Great Yarmouth Third River Crossing

Document 7.4c: Design Report: Appendix C – RSA Stage 1 Report

STAGE 1 SAFETY AUDIT

**GREAT YARMOUTH: THIRD RIVER CROSSING -
ADDENDUM - DEPARTURES FROM STANDARD**

6.0 Problem Location Plan

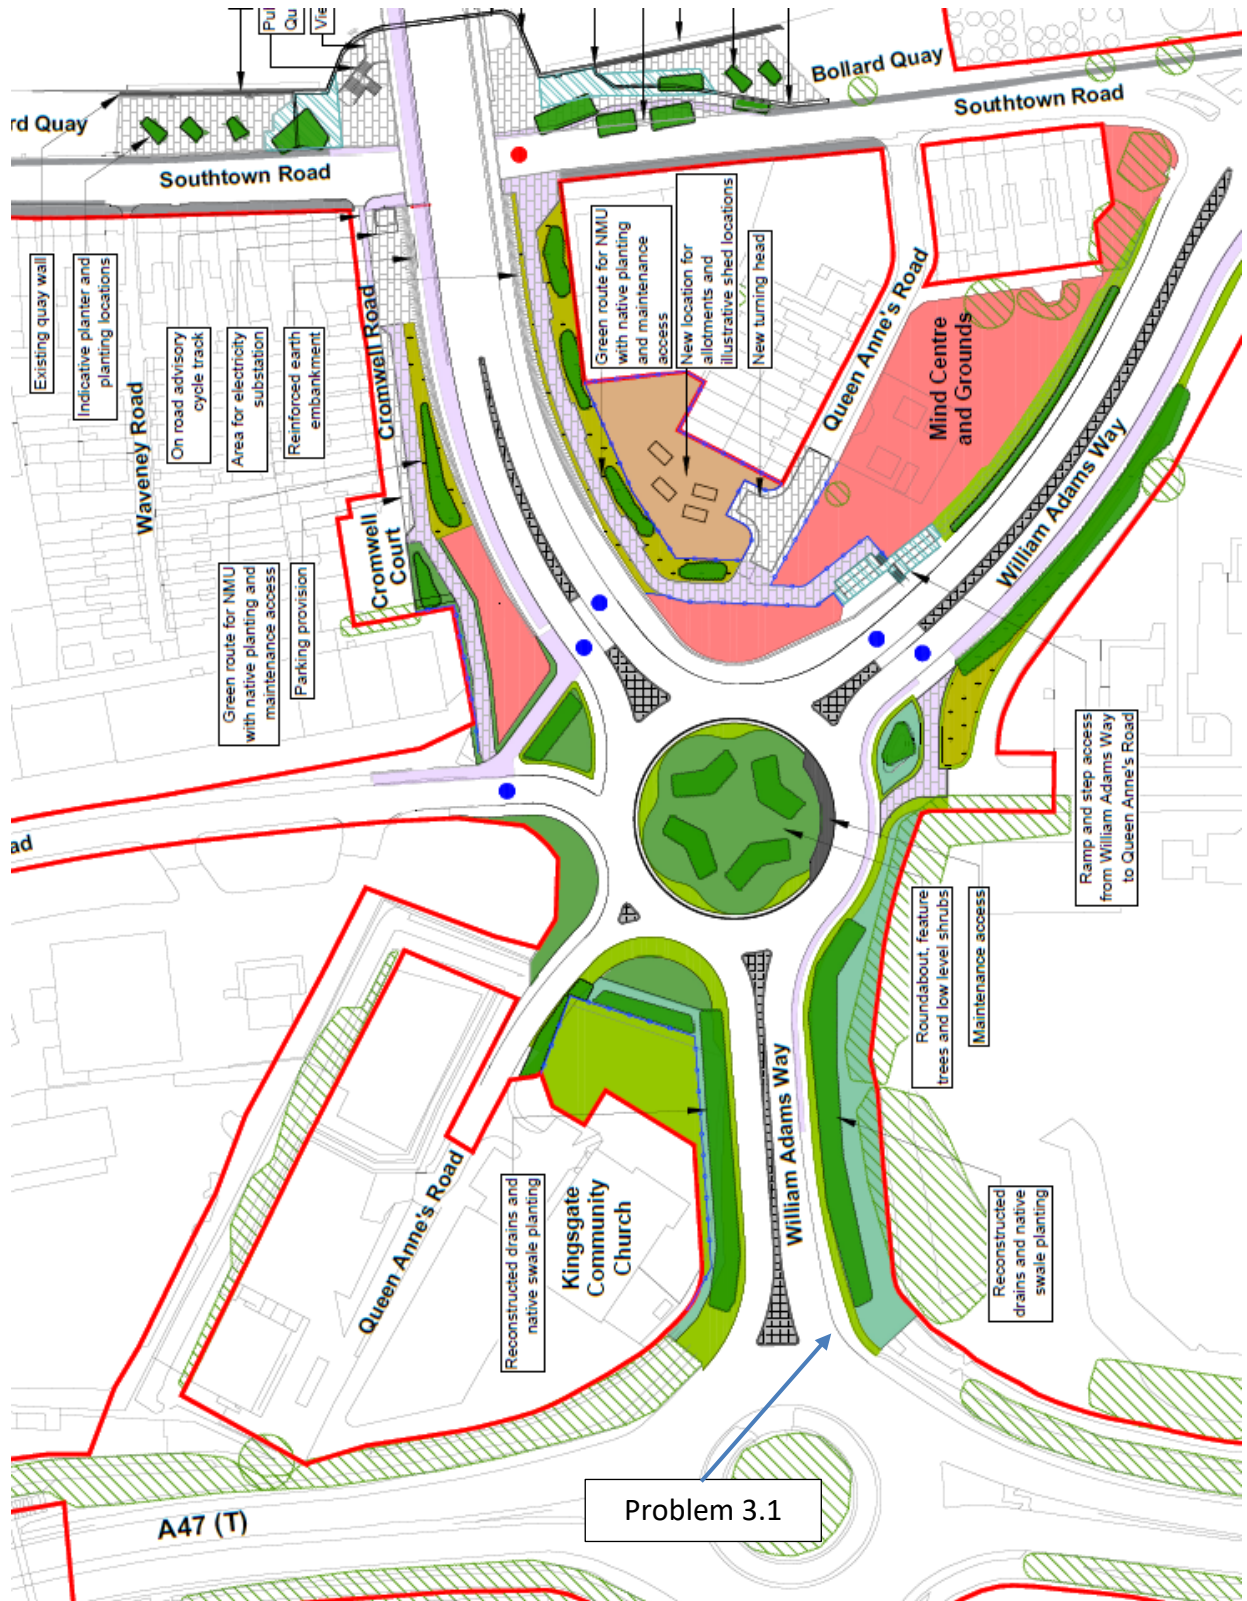
3.1 Problem – failure to give way / tail end / loss of control collisions

Location – east arm of existing A47 / William Adams Way roundabout

Whilst the scheme improves the existing entry path radius at this arm, the resultant value is approximately 250m, compared with the absolute maximum of 100m from *TD16/07*.

Entry path radius is the most important determinant of safety at a roundabout and an excessive figure allows vehicles to enter the roundabout and circulate at higher than desirable speeds. This increases the risk of failure to give way, tail end, or circulatory carriageway loss of control type collisions due to the higher approach speeds engendered by the geometry. Consideration of the six year (to end January 2019) accident records for this junction shows six collisions of this type occurring on this east arm. The provision of the third river crossing will increase traffic flow at this roundabout and it may therefore be anticipated that an increased number of collisions will occur.

Recommendation – a subsidiary deflection island should be provided between the nearside and central lanes. See *TD51/17 – Segregated Left Turn Lanes and Subsidiary Deflection Islands at Roundabouts*.

Preliminary investigations into the provision of a TD 51/17 compliant subsidiary deflection island and associated hatched markings, between the nearside and straight-ahead lanes, have been carried out and these are summarised on the attached sketch. The sketch is based on the provision of a physical subsidiary deflection island, as opposed to a non-physical subsidiary deflection island, as the latter are subject to abuse by drivers crossing the hatched road markings and therefore are less effective than physical islands. The key findings from this exercise, detailing why the recommendation is not accepted, are as follows:

To mitigate the safety concerns raised, in particular those regarding high entry speeds due to non-compliant entry path radius, it is proposed to provide appropriate visibility screening in the central reserve on the approach to Harfrey's roundabout to as described in TD 16/07 paragraph 8.8. Further details of the type of screening proposed would form part of the Stage 2 RSA submission.

Network Management Decision: Accepted on the basis that land required for additional widening on the south side of William Adams Way is not available. The suggestion of installation of vegetation screening to reduce likely roundabout entry speed is accepted and will be considered in detail at Stage 2 Audit.

Figure 1.1 – Location of Highway Geometric Departures

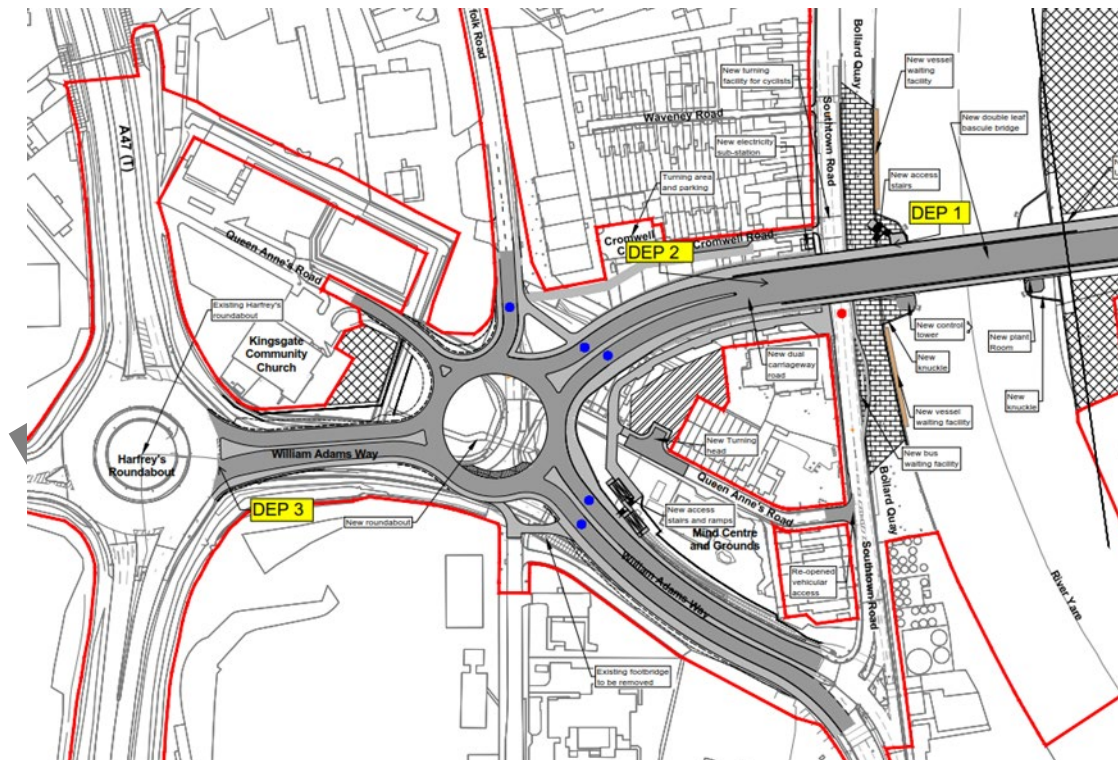
- Discontinuous parapet / barrier provision where *TD19/06 – Requirement for Road Restraint Systems* would mandate linking two adjacent systems with less than 50m between them. This results from the need to provide stepped pedestrian access to a viewing platform on the northwest corner of the bridge. Notwithstanding this requirement, the break in the parapet is coincident with a proposed Class N1 containment Vehicle Restraint System (VRS), separating the eastbound bridge carriageway from the proposed shared pedestrian / cycle facility. Hence, the proposed VRS would prevent an errant vehicle from reaching the gap in the bridge parapet wall.

- Substandard median separation between opposing carriageways of 0.8m where *TD27/05 - Cross-Sections and Headrooms* would mandate 1.8m. The new bridge will be subject to a 30mph speed limit and adjoins constrained, entirely urban highway environments. The geometry of the link has been designed in accordance with TD9/93 and the risk of cross over collisions is considered low.

- Substandard entry path radius where the scheme ties into the existing A47 / William Adams Way. Existing entry path radius is more than three times the 100m maximum mandated in *TD16/07 - Geometric Design of Roundabouts*. The proposed scheme improves this somewhat, but the value is still more than double the mandated value.
